Reference: Docket #'s: 52-014 and 52-015

Subject: April 3, 2008, Citizen Comment of Garry L. Morgan to Scoping Session,
Environmental Impact Statement Bellefonte Nuclear Plant Units 3 and 4
COL Application, Environmental Report Omission

Dunlopson 3-1

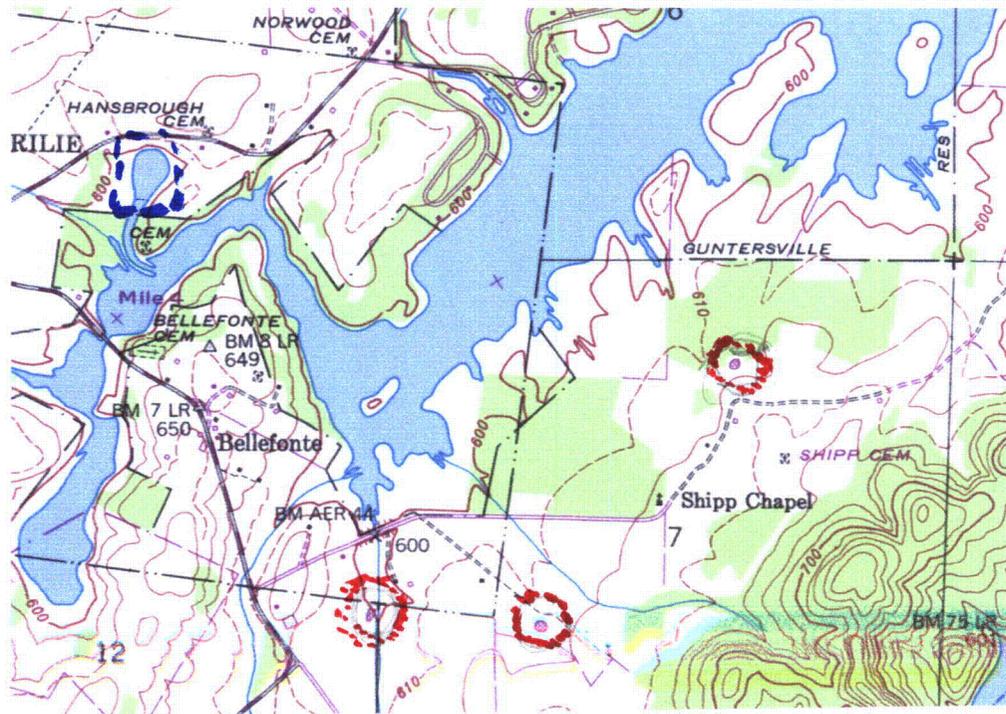
TVA's Environmental Report, Part 3, Hydrogeology, fails to consider historical maps of the area which clearly reflect sinkhole formation on and near the plant site, Inclosures 3-1 thru 4. The word Bellefonte means "beautiful spring.." The Environmental Report on page 2.3-24 states, "No springs were observed in the vicinity of BLN with the exception of small, seasonal and wet weather seeps with no measurable flow." On Inclosure 3-1 the historical "Bellefonte Spring" may be seen about 100 yards west southwest of the Hansbrough Cemetery and outlined in blue on inclosure.3-1 and 3-3, less than 1 mile from the plant site.

Inclosure H

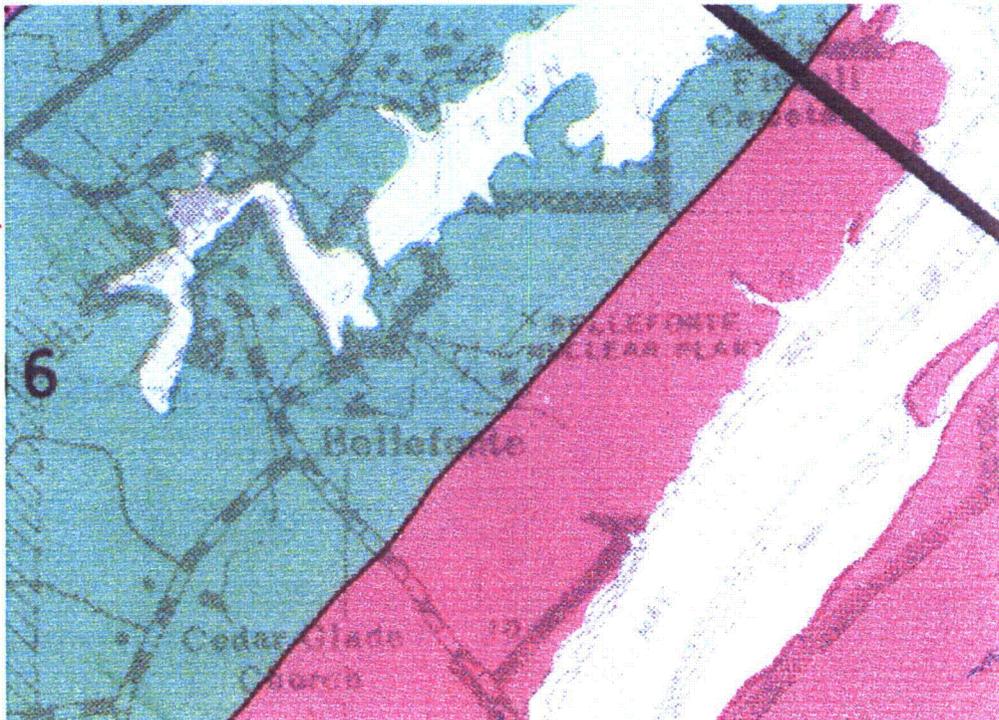
On page 2.3-23, Regional Hydrogeology, the Environmental Report states the aquifer systems of the area reflect a flow which "yields 10-50 gallons per minute, gpm, of water. Inclosure 4, 1989 Geological Survey of Alabama, Groundwater Availability Map of Jackson County reflects yields of 50-500 gpm.

Incident 5-2

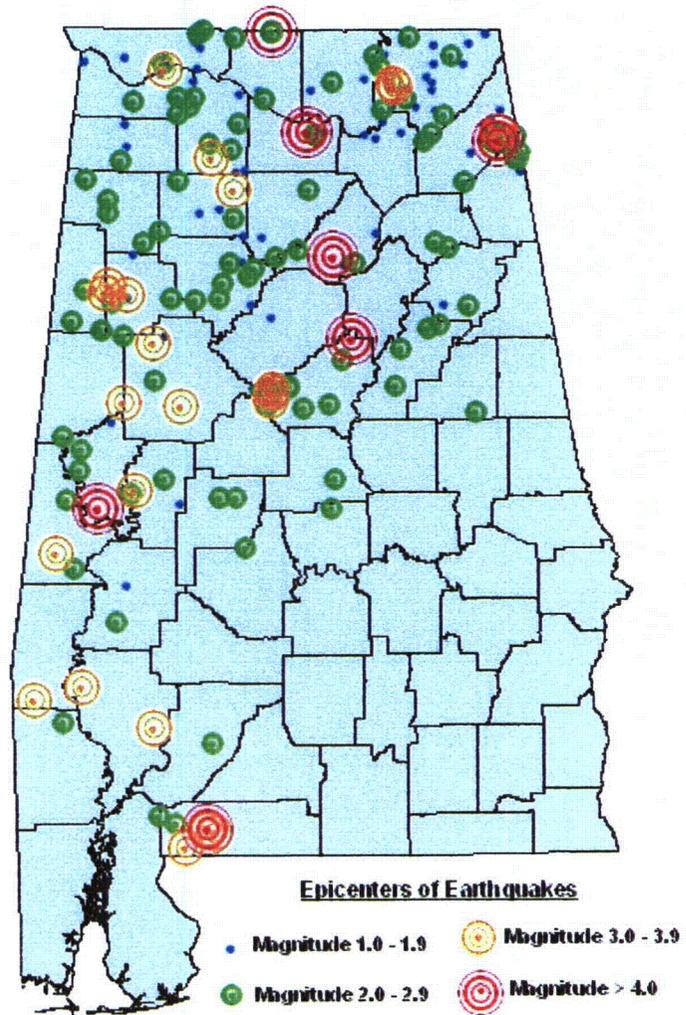
In the COL Application, Part 3, Environmental Report there is no mention of seismic activity and its effects on the "Karst Terrain." Immediately east of the Nuclear Plant is a ridge called River Ridge. River Ridge is a minor fault area. Inclosure 5-1 and 5-2 describes seismic activity in Alabama. If you will notice on the map at Inclosure 5-2 there are several minor earthquakes that have been historically recorded. Earthquake effects on the Karst Terrain have not been discussed in the Environmental Report.
